IN THE DRAWINGS

The attached sheet of drawings includes changes to FIGS. 2, 6, 9, 10, and 13. These sheets, which include FIGS. 2, 6, 9, 10, and 13, replace the original sheets of FIGS. 2, 6, 9, 10, and 13.

Ravi Nair, et al.  
AUS9-2000-0001-US1

FIG. 2

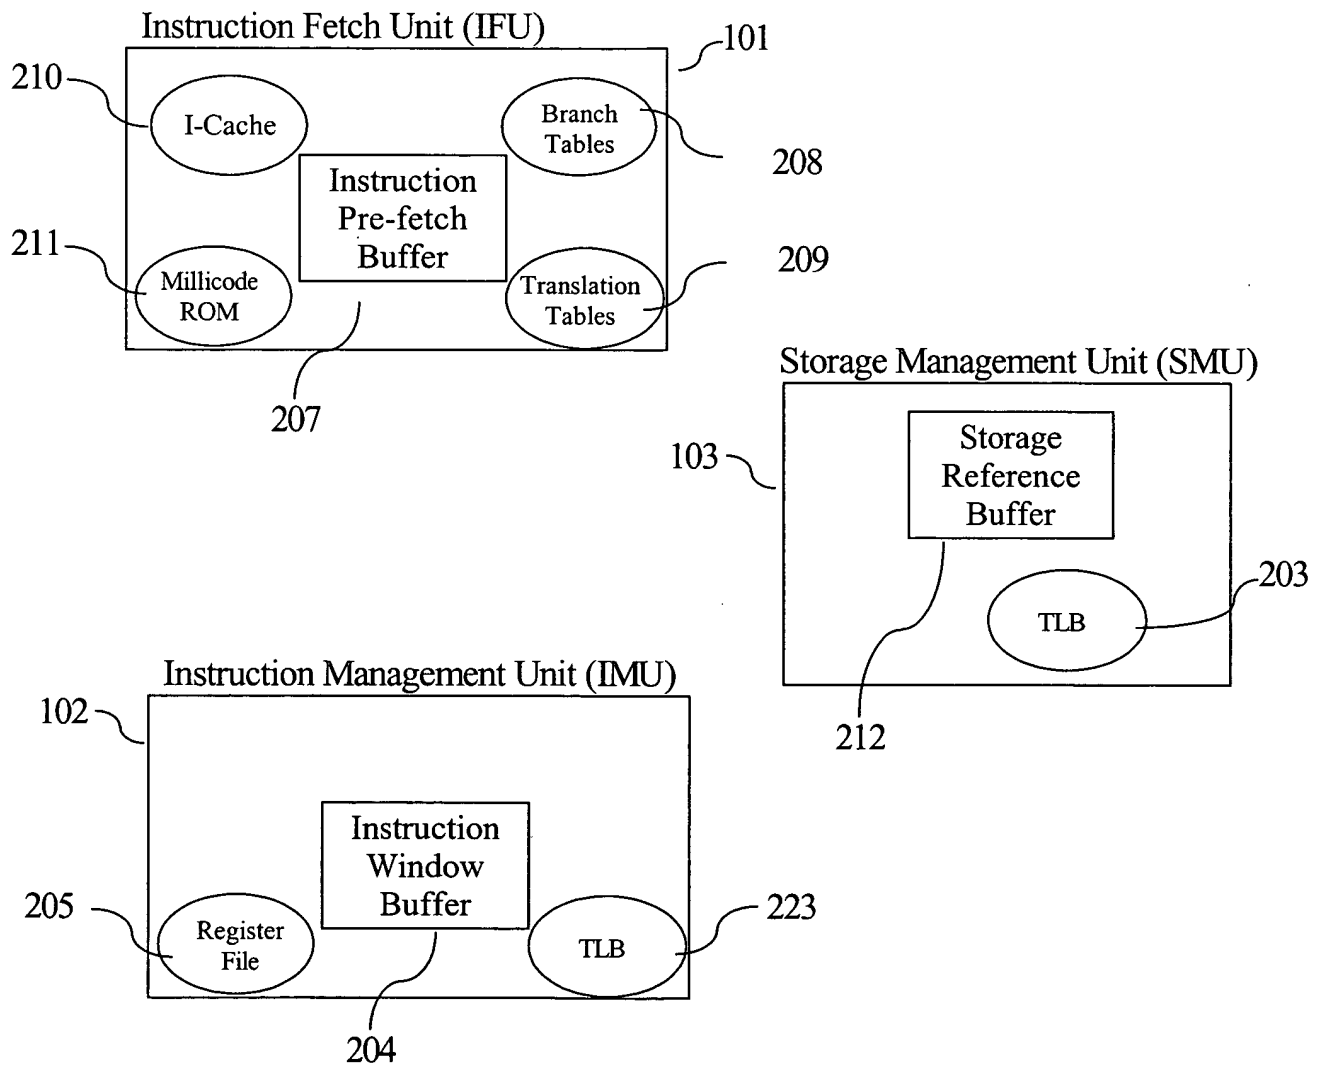
FIG. 2 has been amended to change the TLB 203 in SMU 103 to TLB 223.

9/13

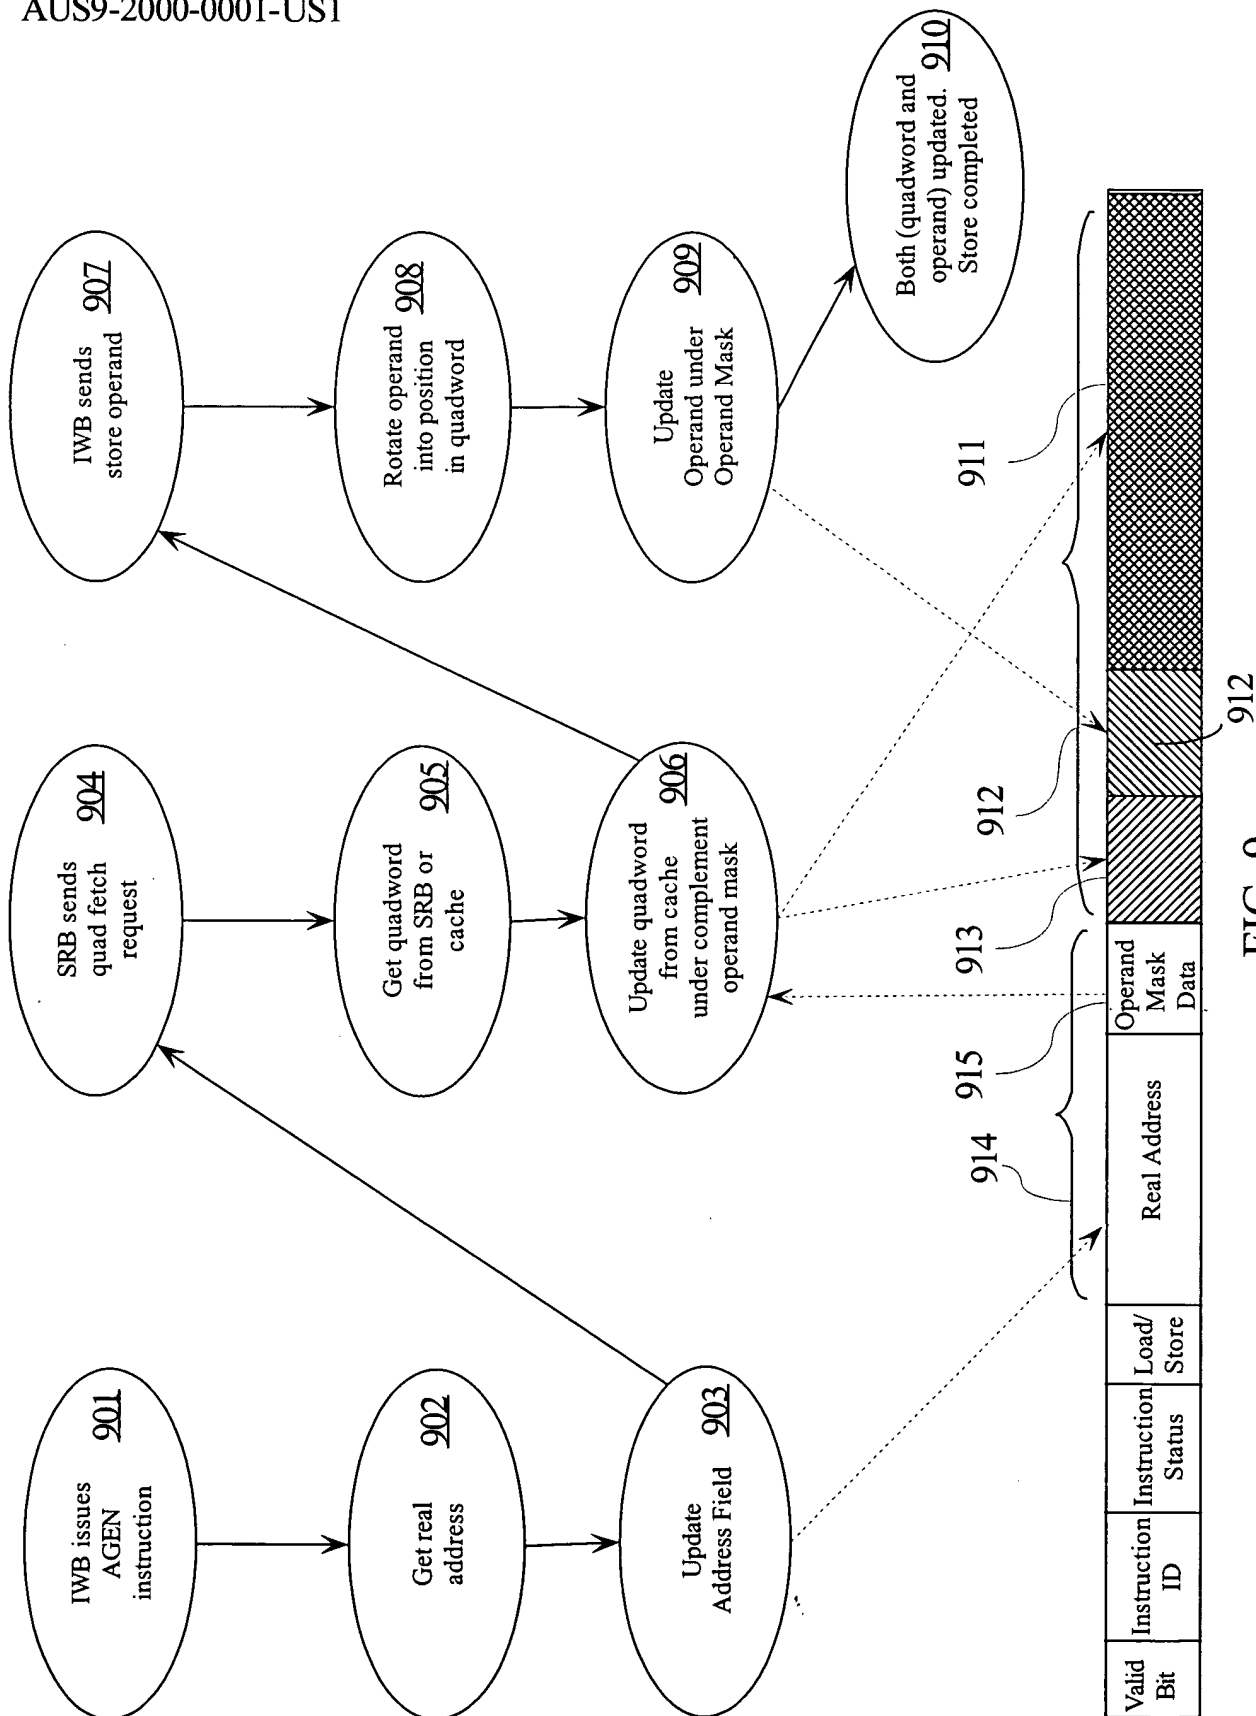
FIG. 9 has been amended to add a couple of brackets to more clearly indicate that 912 is the Quadword and 911 is a portion of the Quadword under a complement Operand Mask. FIG. 9 has been further amended to add a couple of brackets to more clearly indicate what is Real Address 914 and what is Quadword 912. A new designator 916 was added that corresponds to the section of Quadword 912 pointed to by step 909 as "Operand Mask." Likewise, to avoid confusion section 915 was renamed "Operand Mask Data" from "Operand Mask." The Operand Mask Data 915 defines which portion of Quadword 912 is the "Operand" under the "Operand Mask 916" updated in step 909.

FIG. 10

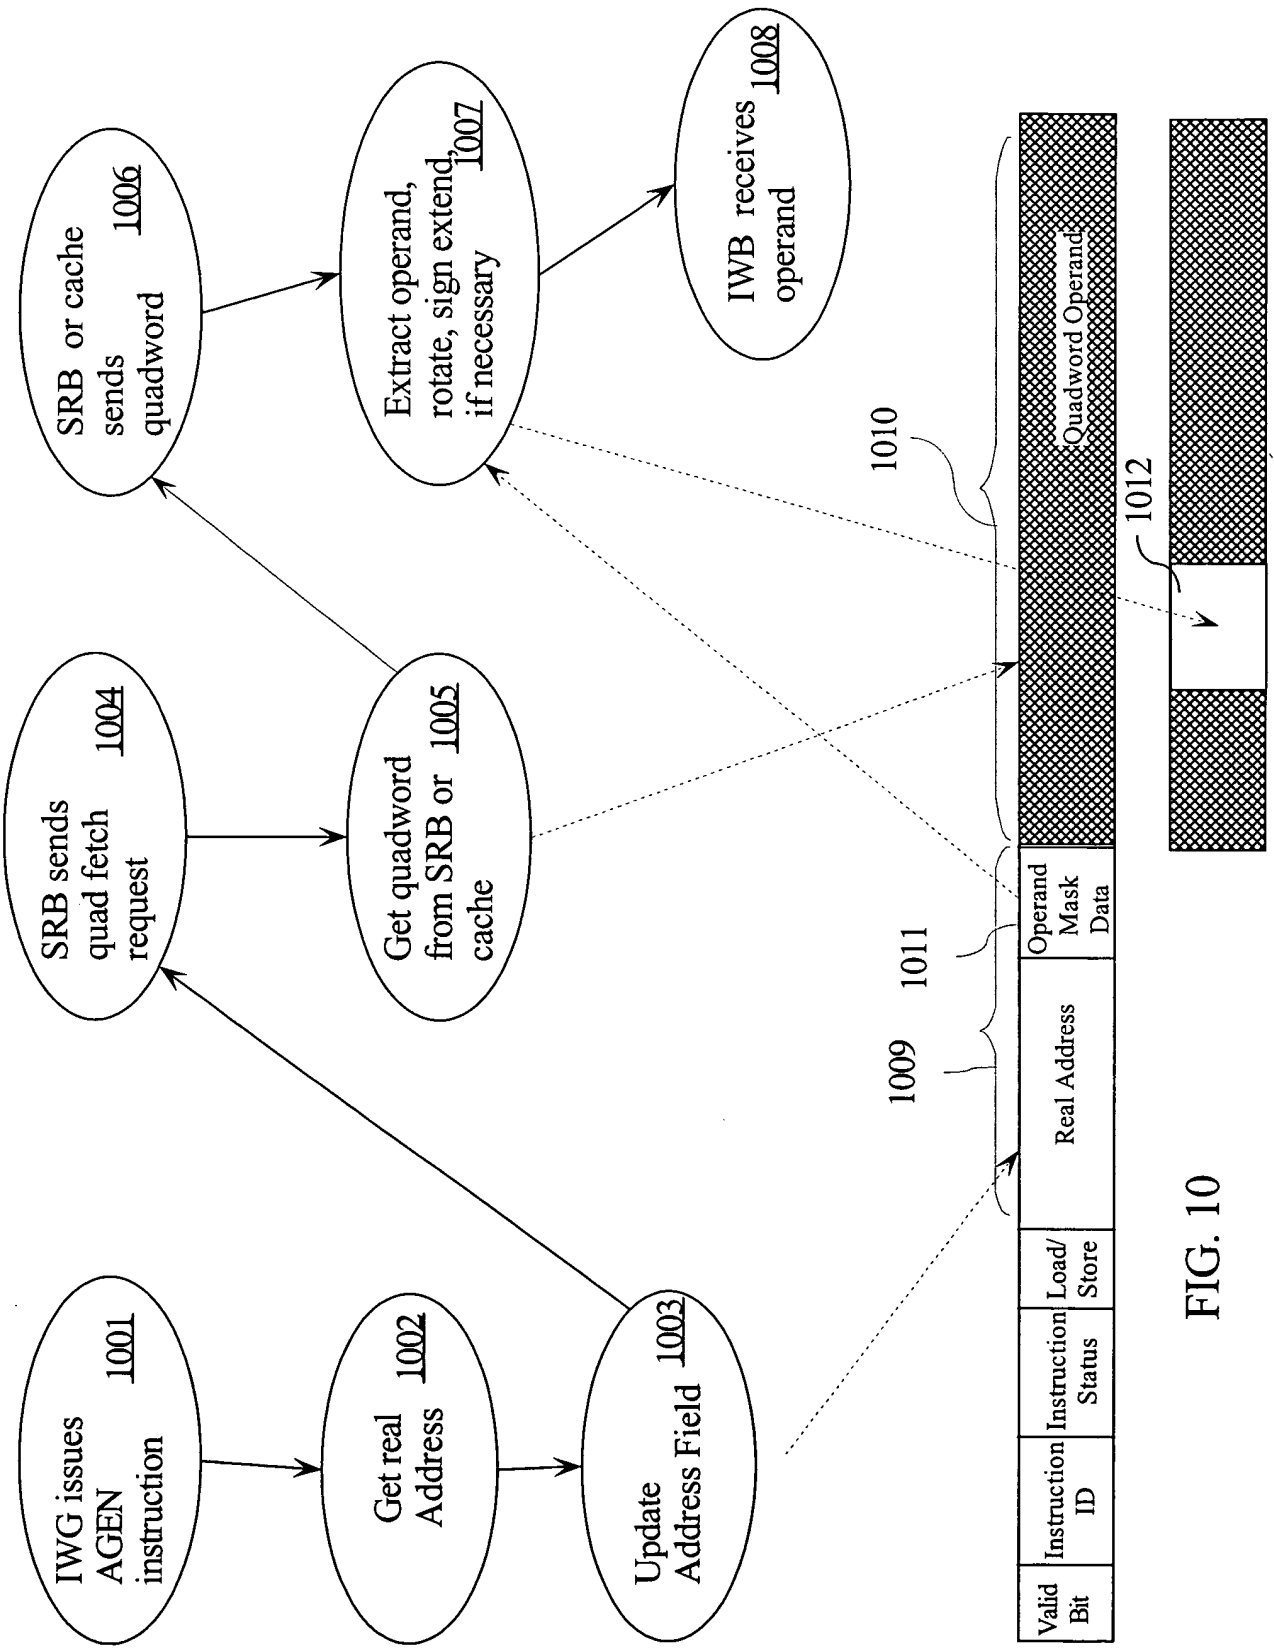
FIG. 10 has been amended to add a couple of brackets to more clearly indicate what is Real Address 1009 and what is Quadword 1010. A new designator 1012 was added that corresponds to the section of Quadword 1010 pointed to by step 1008. Likewise, to avoid confusion section 1011 was renamed "Operand Mask Data" from "Operand Mask." The Operand Mask Data 915 defines which portion of Quadword 1010 is the "Operand" under the "Operand Mask 1012" extracted in step 1008.

FIG. 13

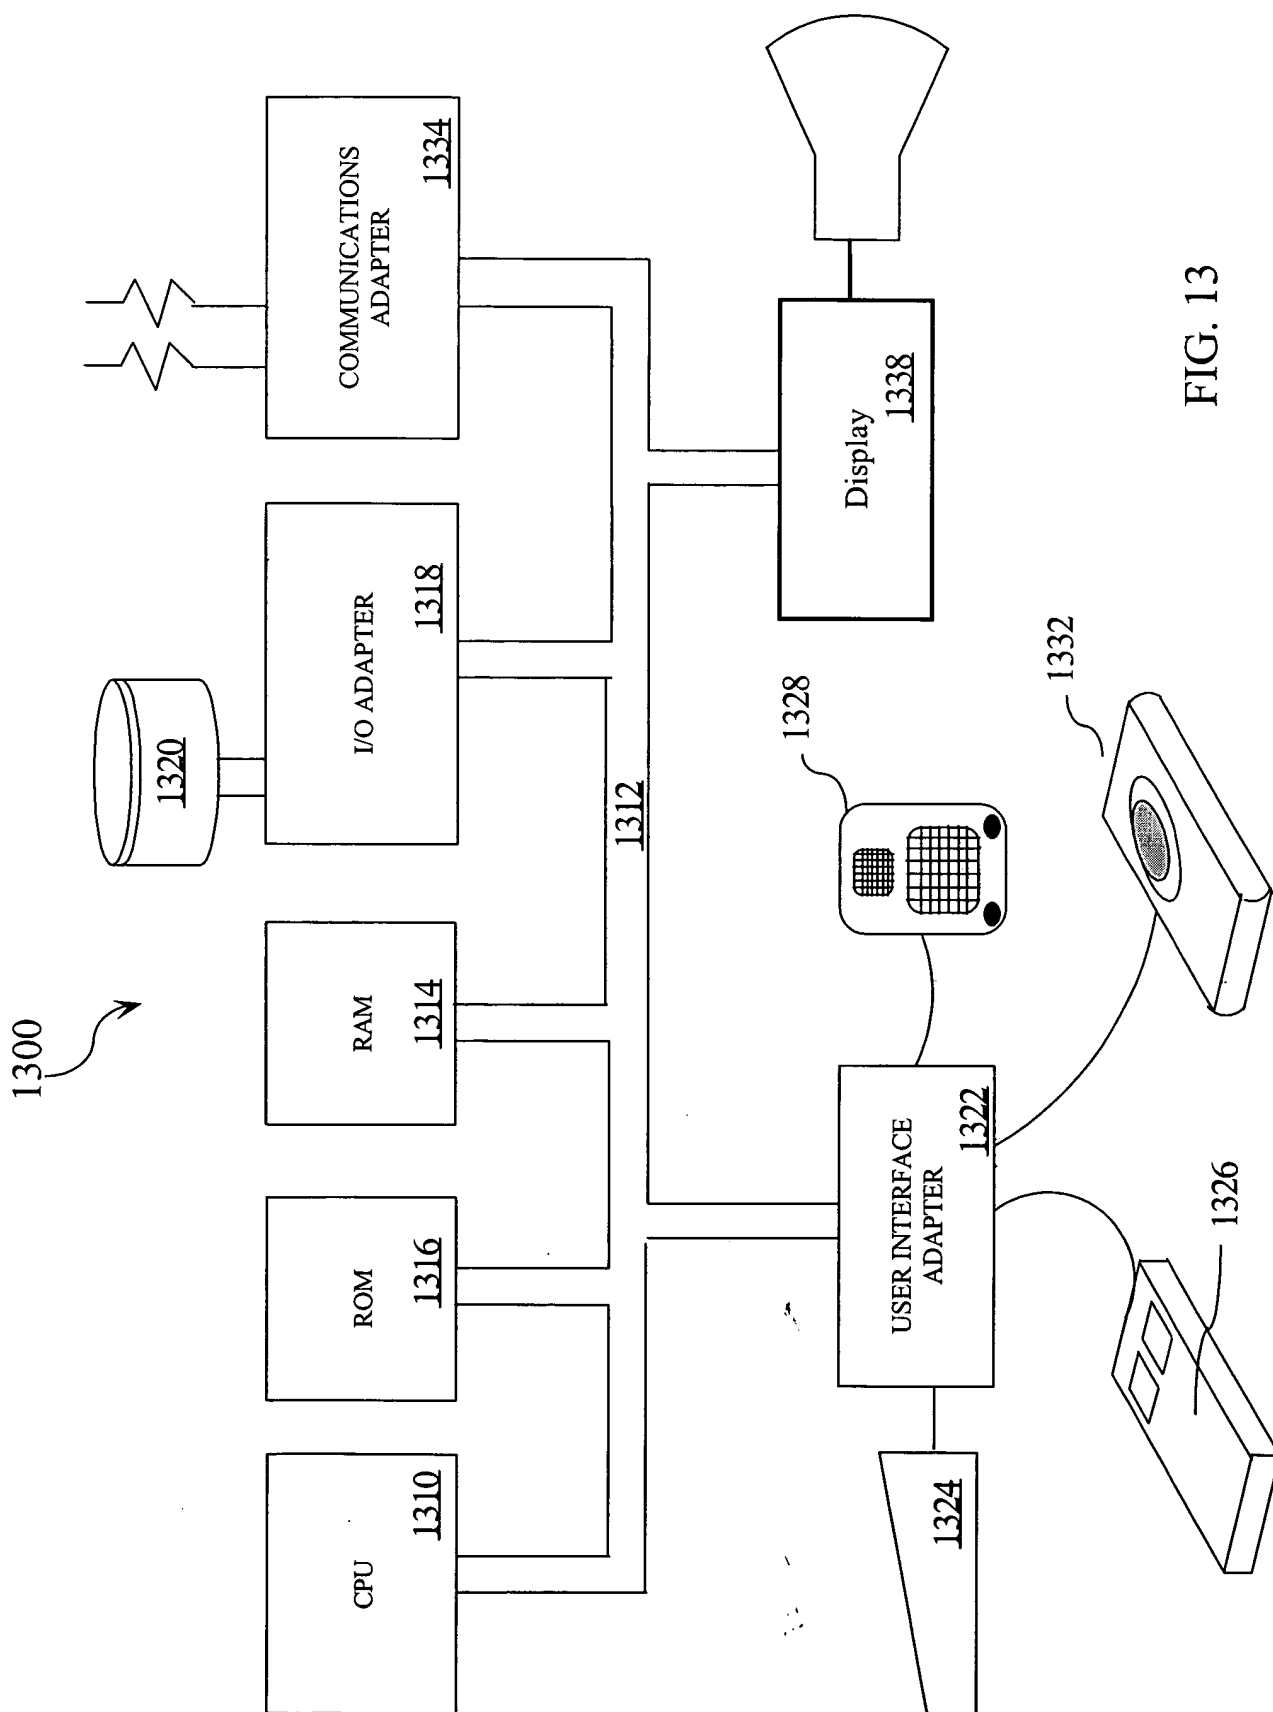
FIG. 13 has been amended by deleting element 1340 so FIG. 13 conforms to the Specification. The Specification has been amended to conform to the designators used for mouse 1326 and trackball 1332. FIG. 13 has been further amended to add display 1338 so that the FIG. 13 conforms to the Specification. The Specification has been

amended changing designator 1323 to 1332 to conform to FIG. 13. FIG. 13 has been amended to drop element 1340 for which there is no description. The Specification is amended to change the designator 1323 to 1326 to make the Specification conform to FIG. 13.
